| Project | IEEE 802.16 Broadband Wireless Access Working Group < http://ieee802.org/16 > | |
| Title | Private Map Message and CQICH Direct Signaling in the AAS Relay Zone. | |
| Re: | Working Group Letter Ballot Recirc #28b, Technical Comments and Contributions regarding IEEE Project P802.16j; Draft Amendment P802.16j/D3. | |
| Abstract | This contribution describes the Direct Signaling Private Map message transmitted in the AAS Relay Zone to accomplish bandwidth grant, physical link adjustment and fast HARQ feedback. | |

Figure xxx: Partition Definition

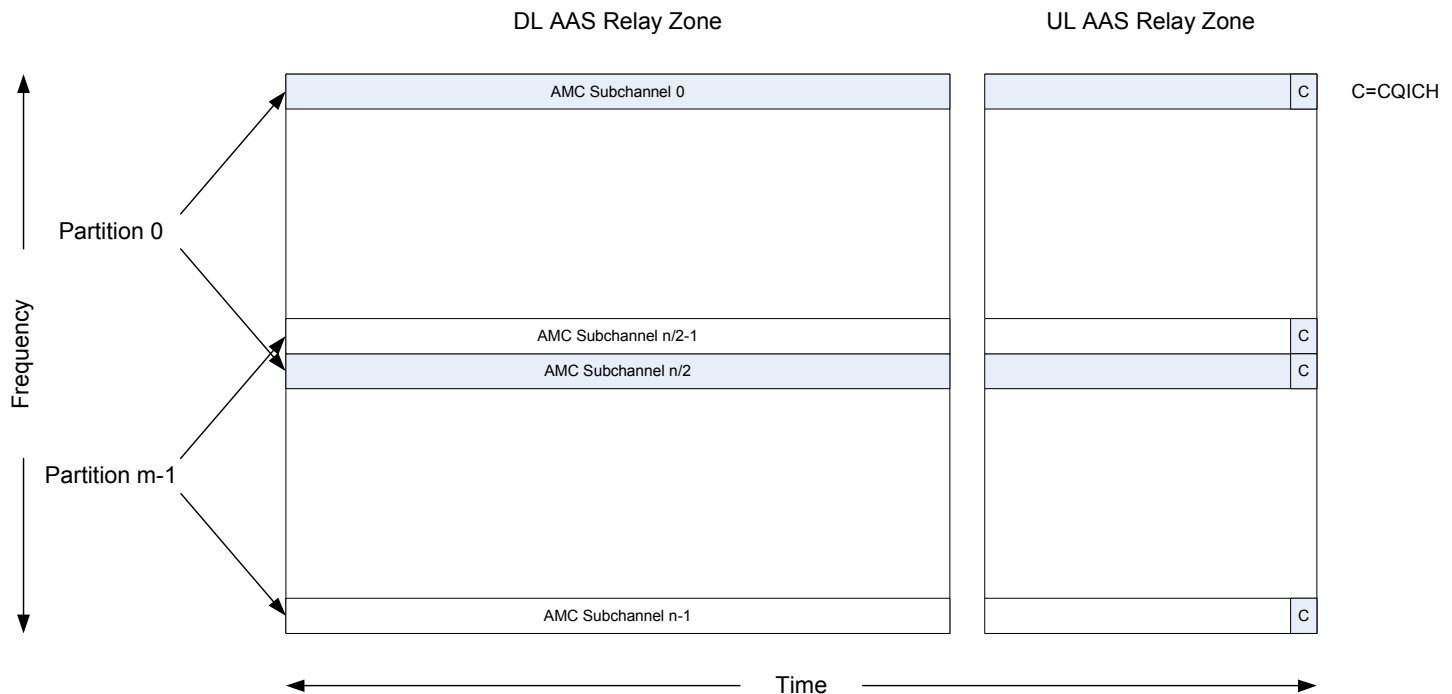
Insert the following subclause 8.4.4.7.3.2.3.6:

8.4.4.7.2.3.6 AAS Relay Zone Messaging

- 1) Partition – a partition of frequency within the carrier channel. AAS-DS partitions utilize AMC slots and are therefore comprised of 1 or 2 bins as defined by the AMC subchannel permutation (1 bin x 6 symbols or 2 bins x 3 symbols). The partition is the smallest unit of allocation granularity within a burst for the AAS Relay Zone. Partitions are numbered with an index in ascending order based on frequency (starting with an index of 0). A partition allocation is a coupled resource allocation which is granted in both the DL subframe and UL subframe for each frame of allocation.

Figure xxx: Initial Ranging Message Sequence in AAS Relay Zone

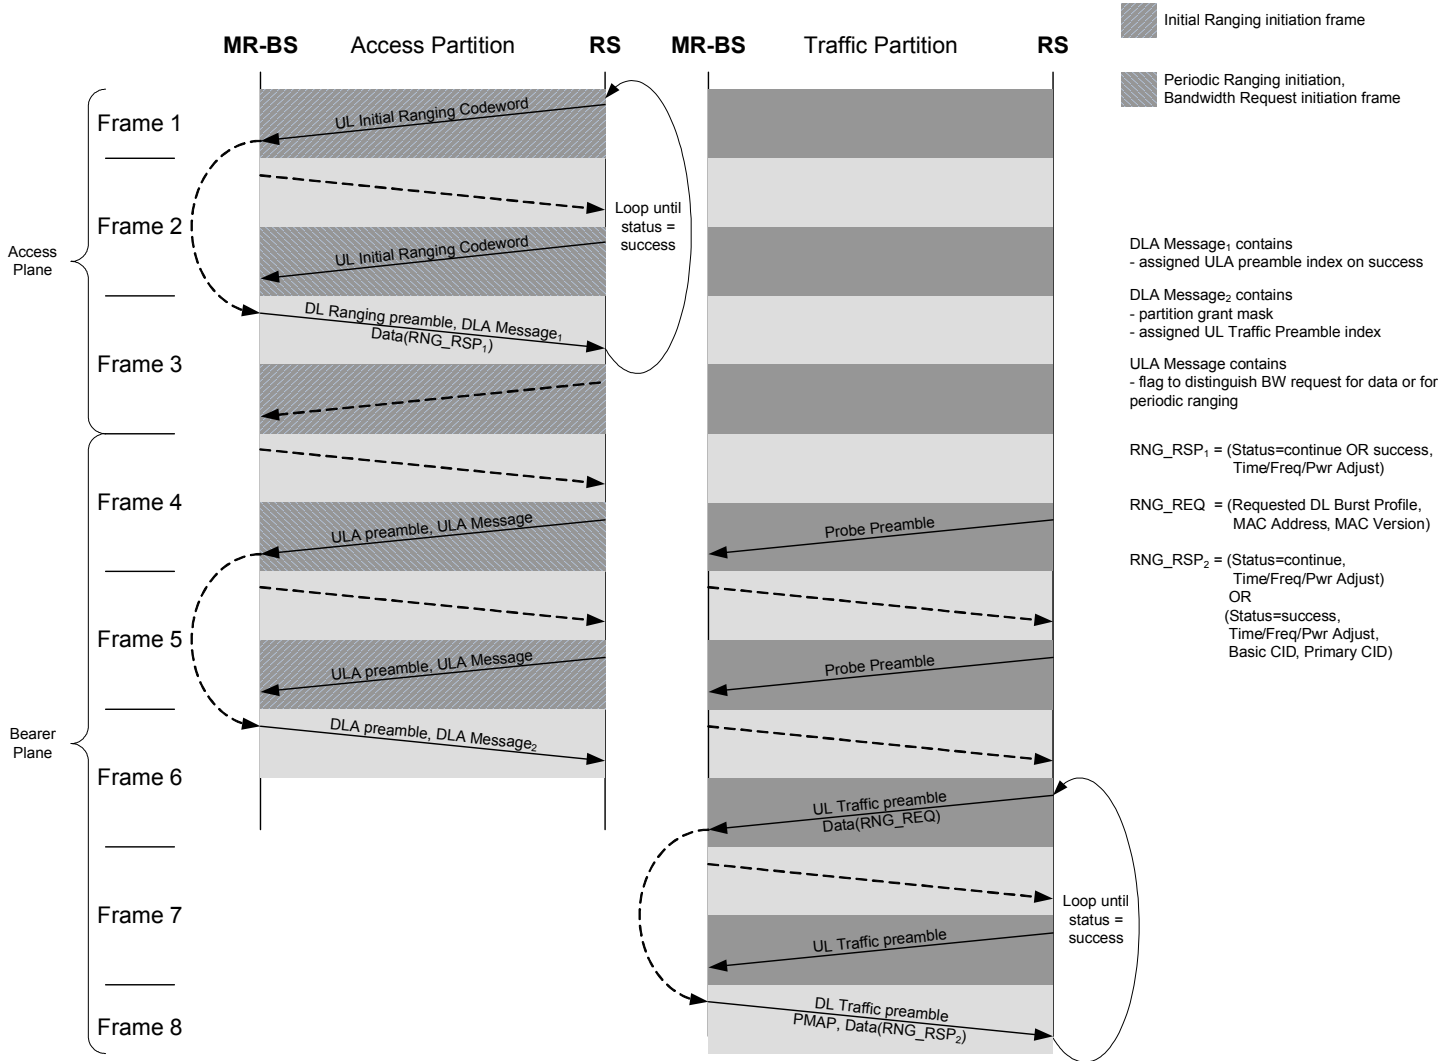
The initial ranging message sequence for an entering RS shows the migration from the Access partition utilizing the DLA for bandwidth grant and physical layer control to a traffic partition as part of a burst

allocation where the PMAP is then used for bandwidth grant and physical layer control. The initial ranging message sequence for an RS entering the network in the AAS Relay zone is as follows:

Figure xxx. Block diagram of CQICH mapper

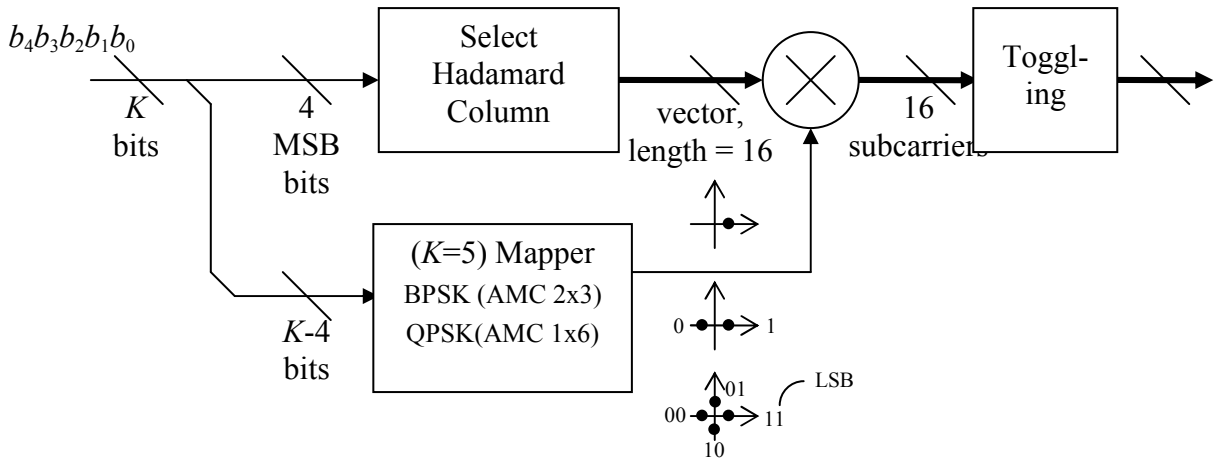
8.4.4.7.2.3.6.2.1 CQICH mapper

We will use $K = 5$ bits. The constellation is BPSK for AMC permutation 2x3 and QPSK for AMC permutation 1x6. The constellation amplitude is unity; no boosting. b_4 is the MSB.

Figure xxx. CQICH bit allocation of 1 partition sub-burst

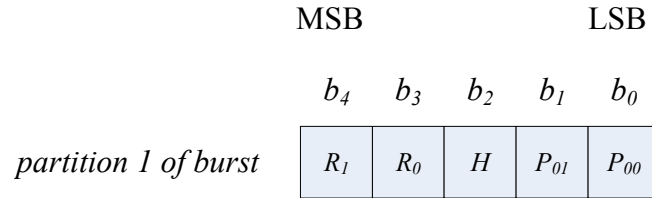
8.4.4.7.2.3.6.2.2.1 For a Burst with only one partition

Note: P_{ij} is defined as power control for each partition, and subscript i denotes partition index, and subscript j denotes power control bit index; H is defined as HARQ acknowledge bit; and R_m is defined as headroom report bits.

Figure xxx. CQICH bit allocation for 2 partition sub-burst

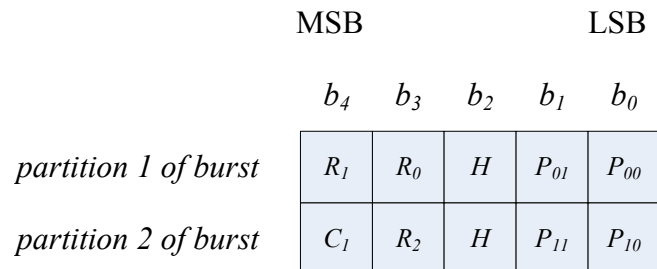
8.4.4.7.2.3.6.2.2.2 For a burst with two partitions

Bit C_1 is used for even parity check across the CQICH bits, except the HARQ bit of the 2nd partition, of the 2 partitions, such as:

At the base station, if the parity check fails or either of the HARQ bits on two partitions are equal to NACK, we assume a NACK was transmitted. During transmission, the HARQ bit of the second partition is identical to the HARQ bit of the first partition.
